EPC STORMWATER REVIEW COMMENTS
IN ORANGE BOXES WITH BLACK TEXT

FINAL DRAINAGE REPORT
for
LATIGO TRAILS FILING No. 10

**AMENDMENT TO MDDP/PRELIMINARY DRAINAGE PLAN
FOR LATIGO TRAILS**

PCD FILE NO. SF2421

Crossing - DP1 Conestoga, Design Discharge - 279.5 cfs
Culvert - DP1, Culvert Discharge - 279.5 cfs

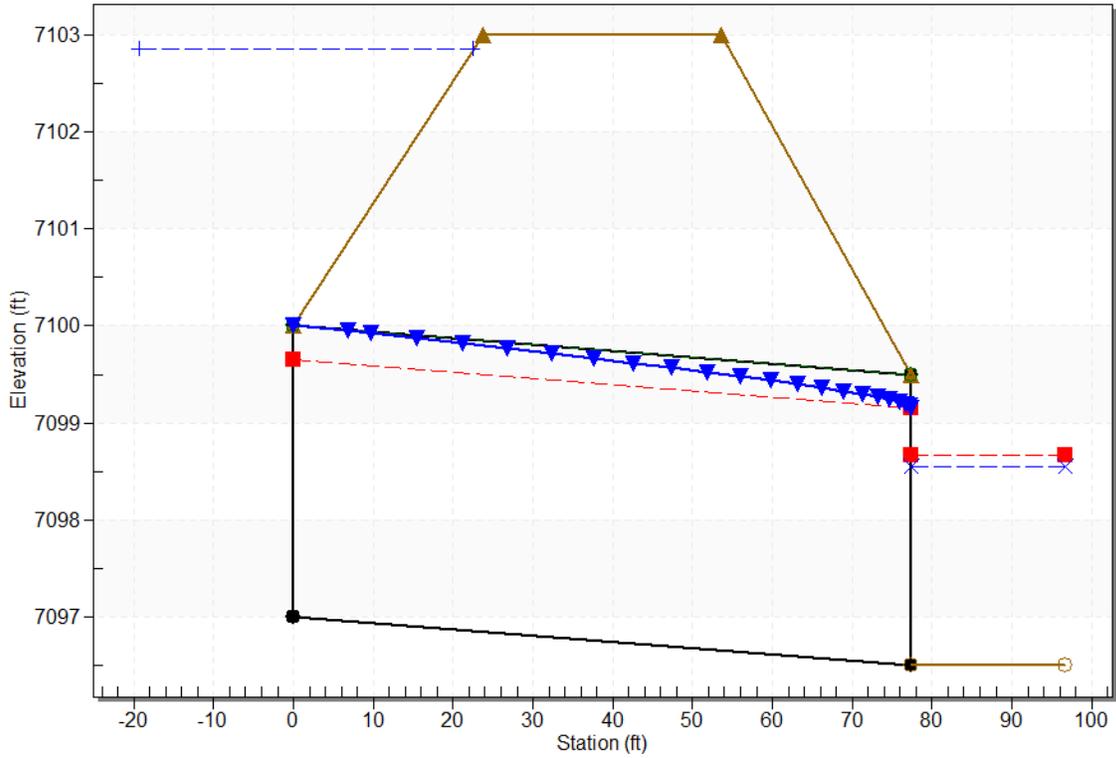
Does not meet criteria in DCM Ch6 table 6-5, Hw/D = 1.5, revise to meet criteria

EXISTING
FILING 10
DRAINAGE MAP
PROJECT NO. 21820-01CSCV
DRAWING NO.

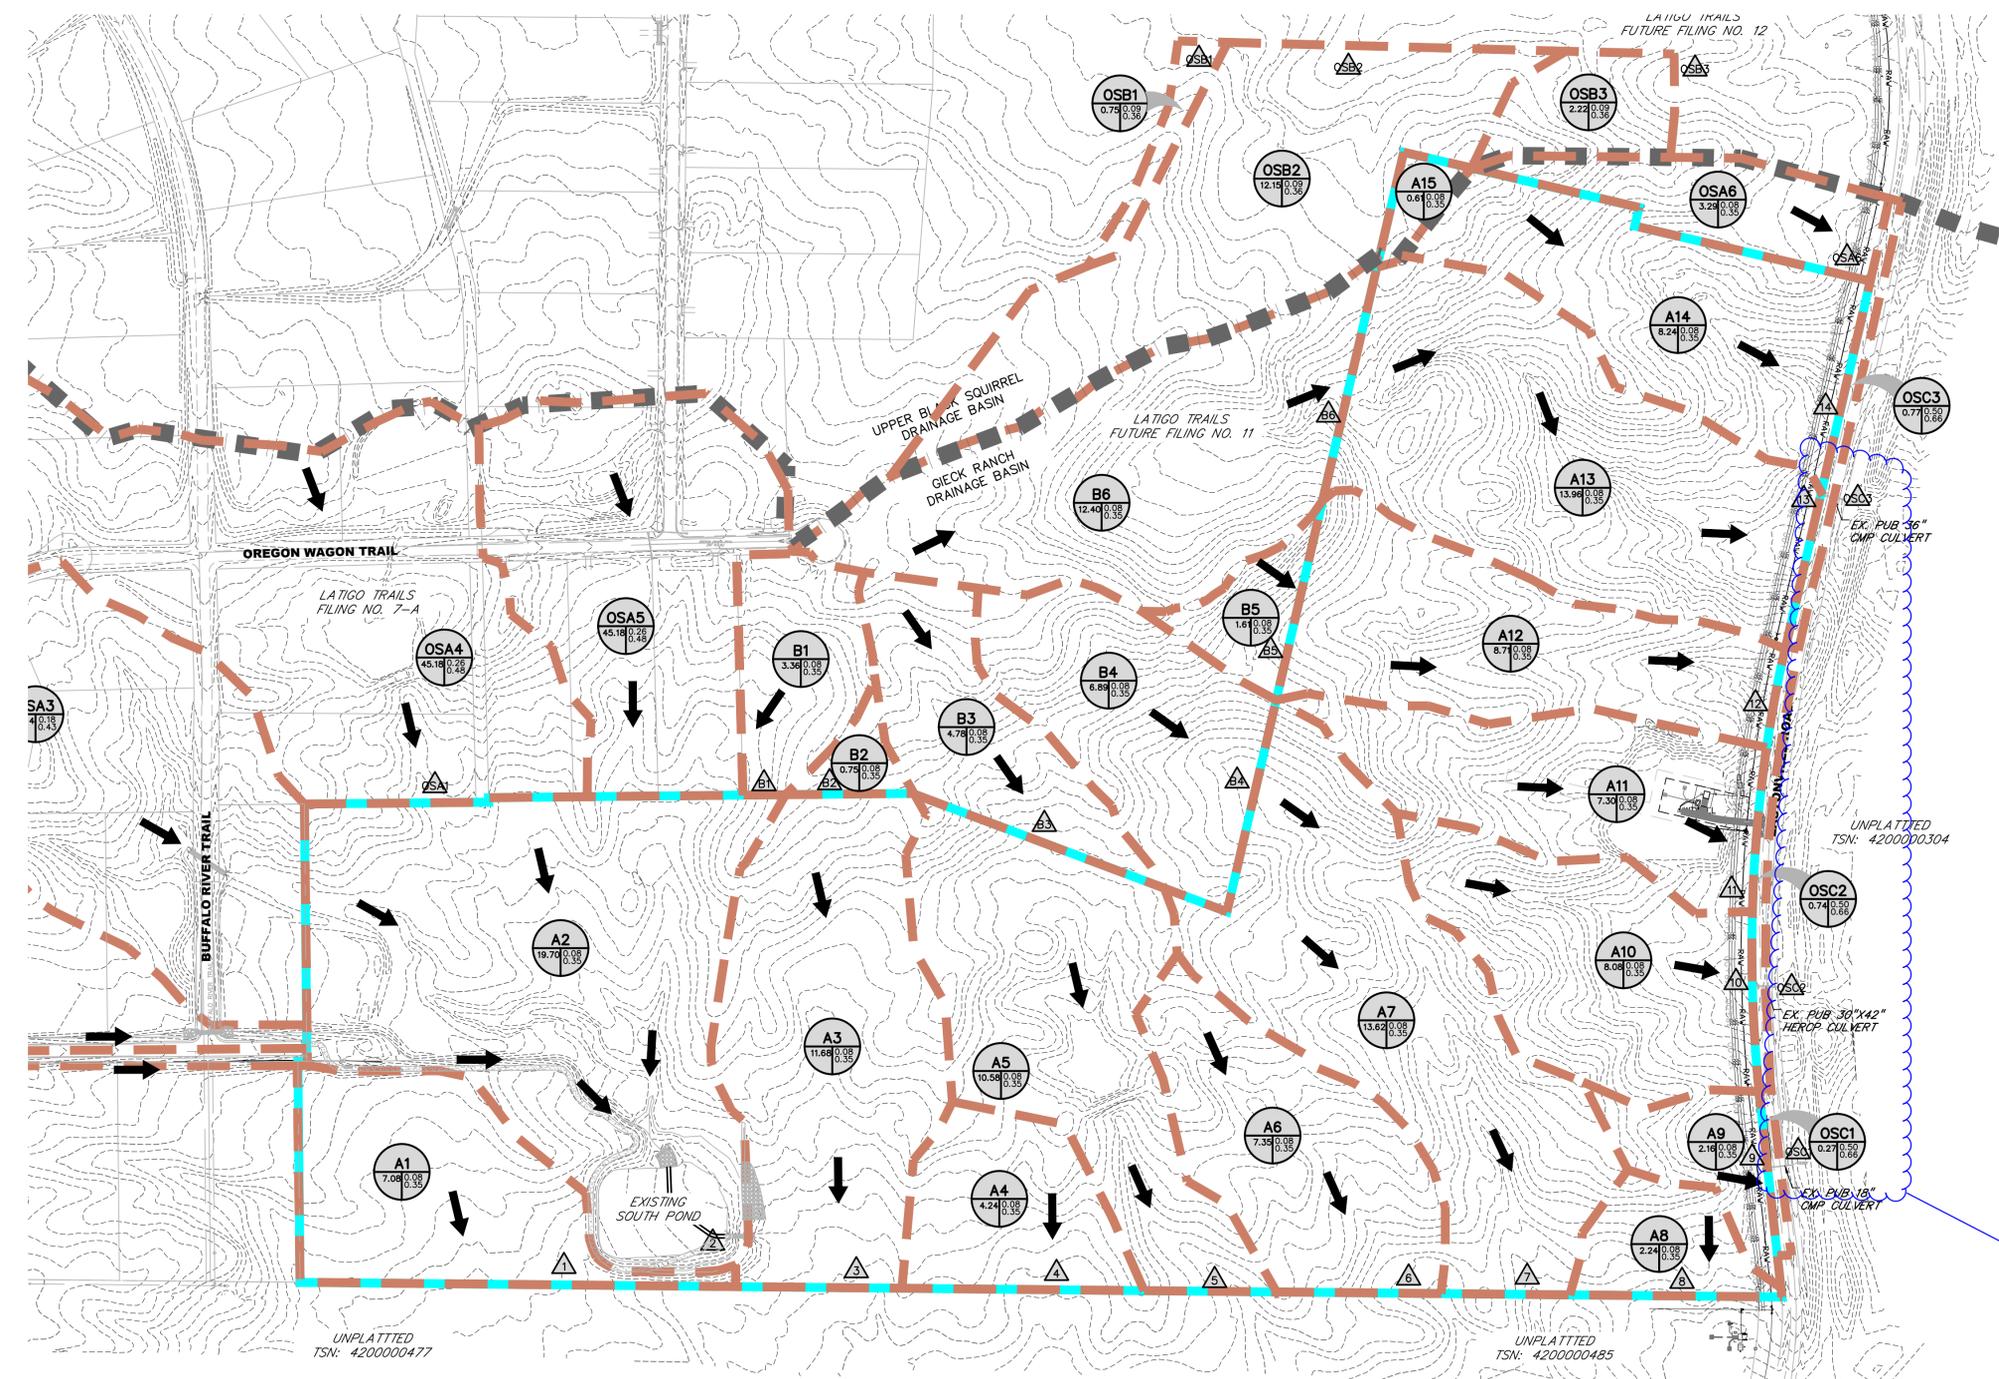
please provide OSC basin and OSC design points in the table summary

SHEET: 4 OF 4

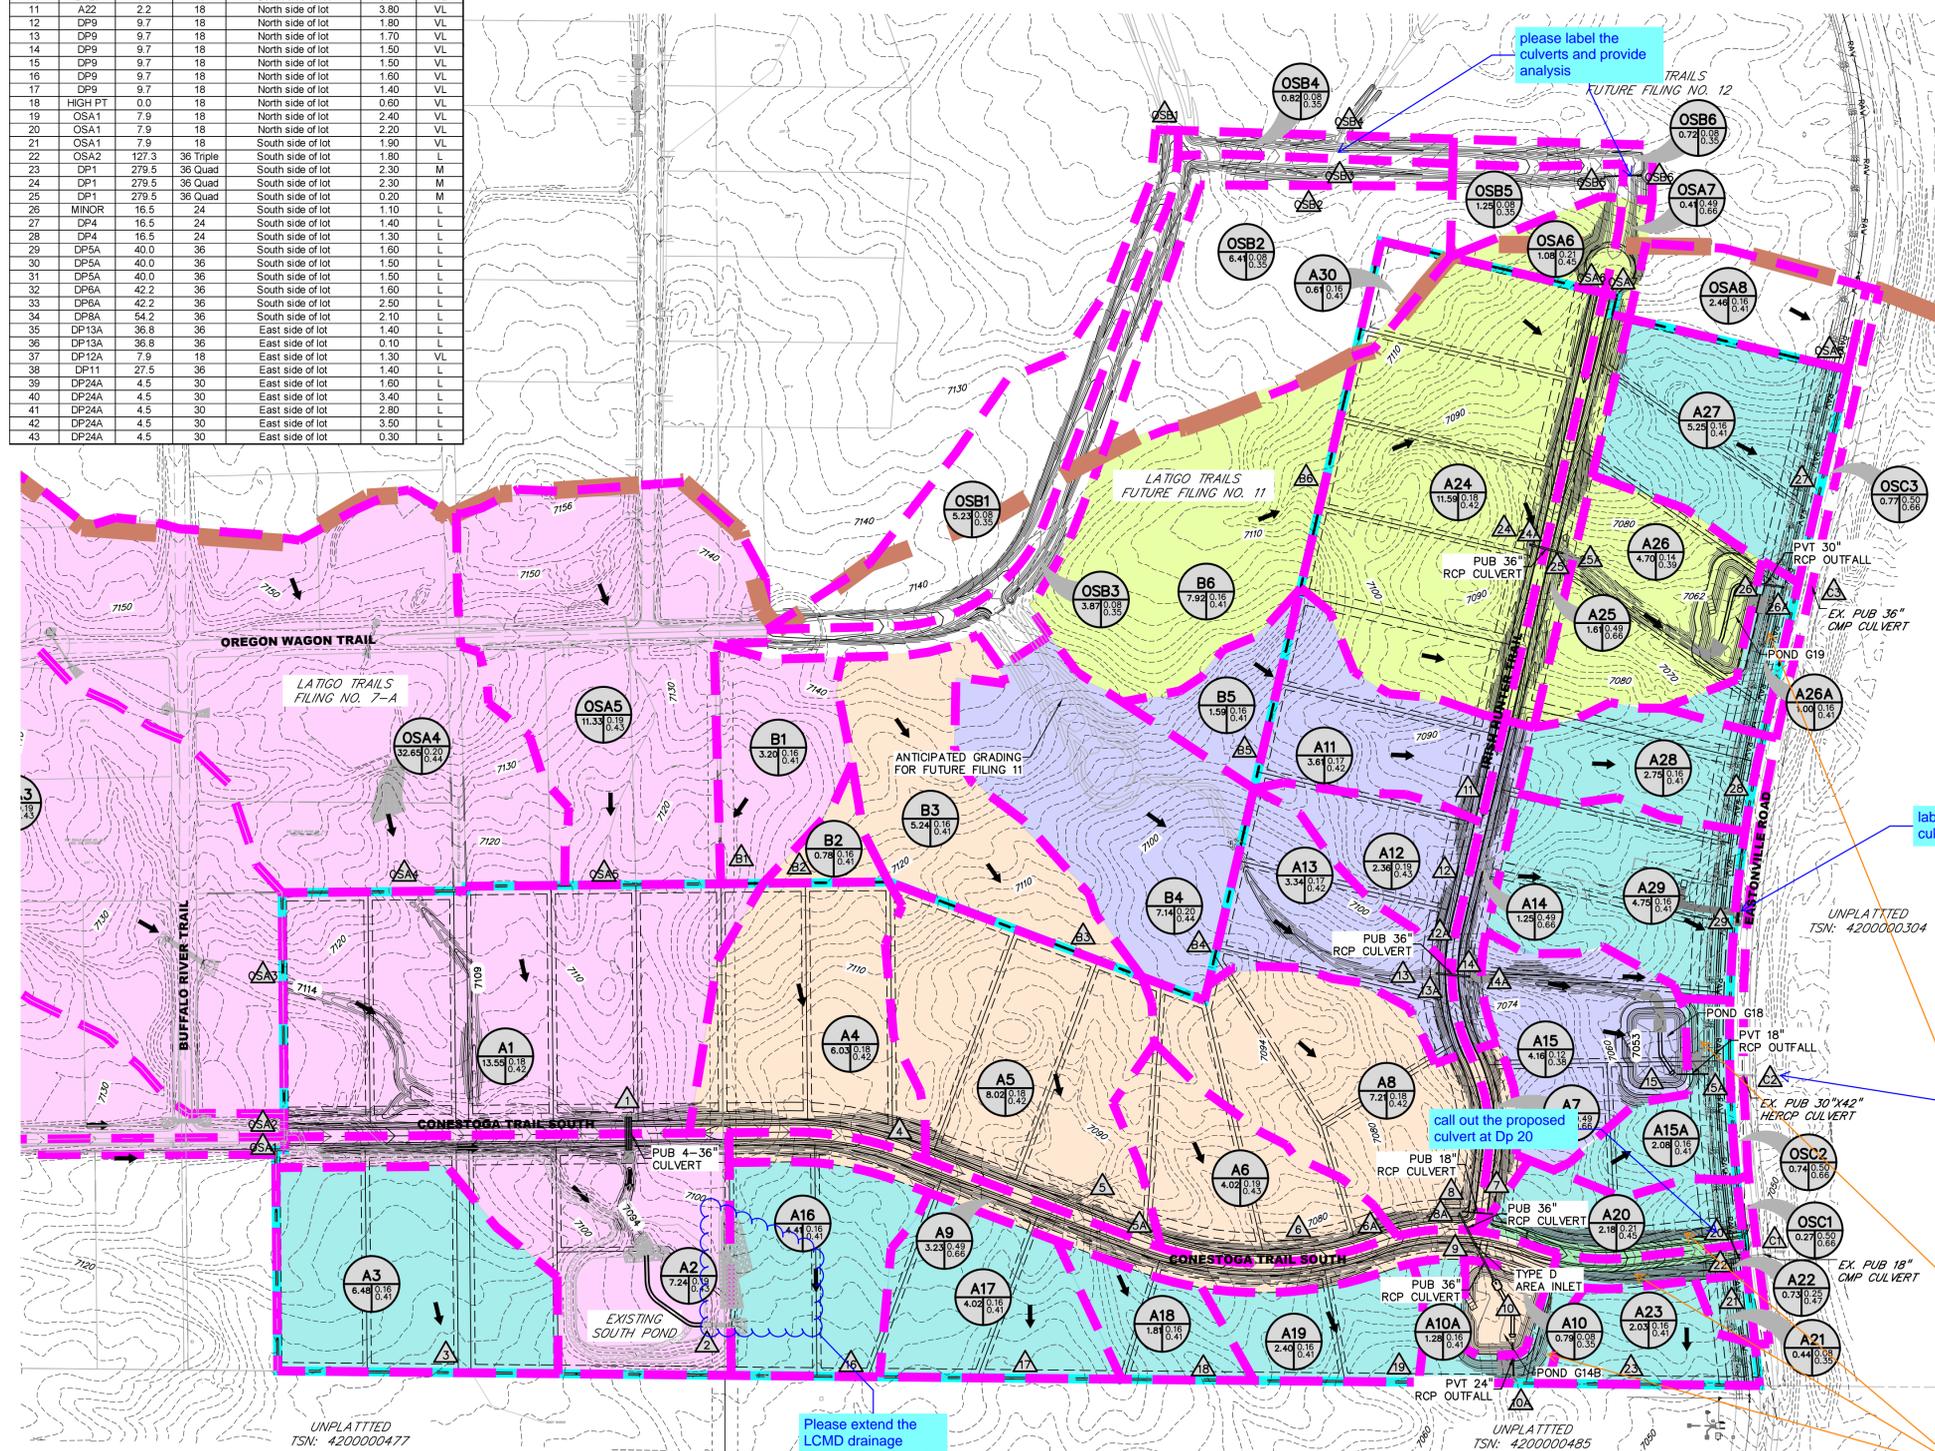
the narrative and table label this as OSC2. Revise for the other "C" design points also for consistency.

This grading for the road and pond is not applicable to Exclusion B.5. These areas will need to be treated and/or you will need to find another applicable exclusion.

please label the culverts and provide analysis
